<b>Interview Summary</b>	<b>Application No.</b> 10/717,425	<b>Applicant(s)</b> GARTON, DARWIN	
	<b>Examiner</b> Stephen J. Castellano	<b>Art Unit</b> 3727

DISCHARGE OUTLET FOR DOUBLE  
WALL CONTAINMENT TANK  
ASSEMBLY

**PROPOSED  
AMENDMENT**

Fig. 4.

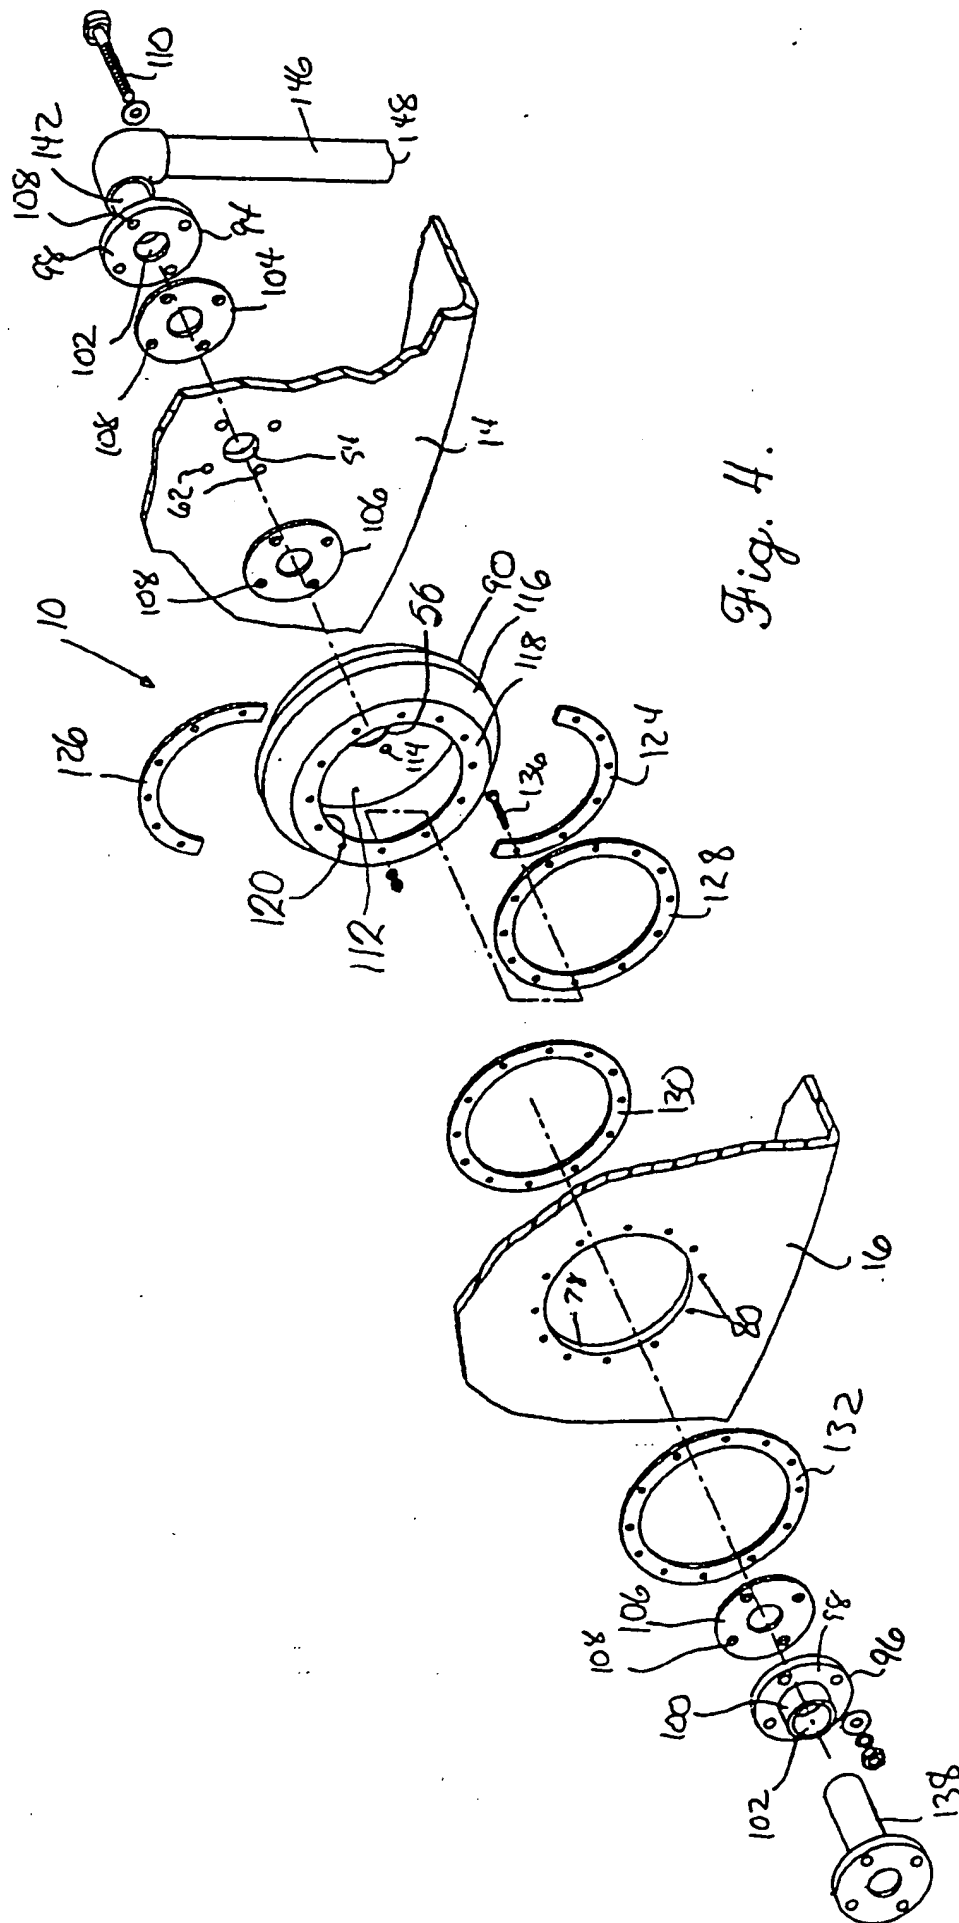
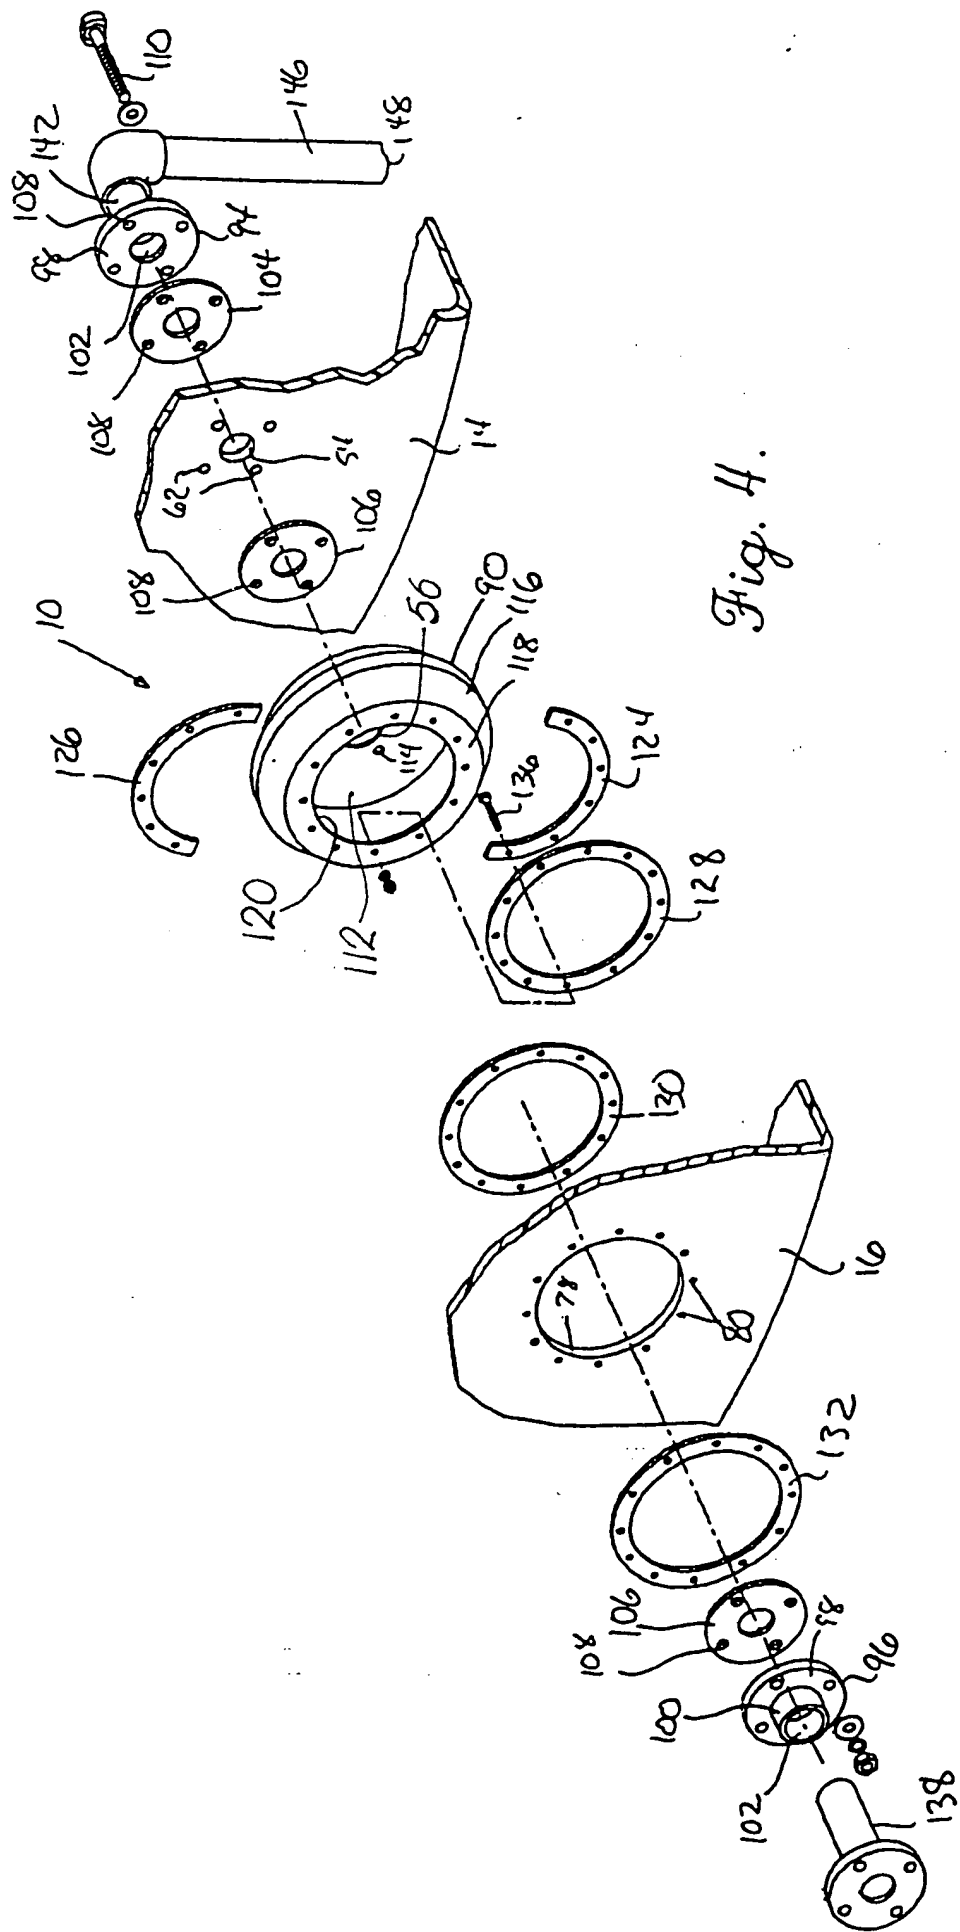
In addition, Fig. 4 has been amended to add three reference numerals, namely the hole 56 in the wall 112, the wall 112, and the hole-defining margin 120 in outer wall 118. Attached is a red-lined markup of Fig. 4, together with a file copy thereof, marked as a replacement drawing.
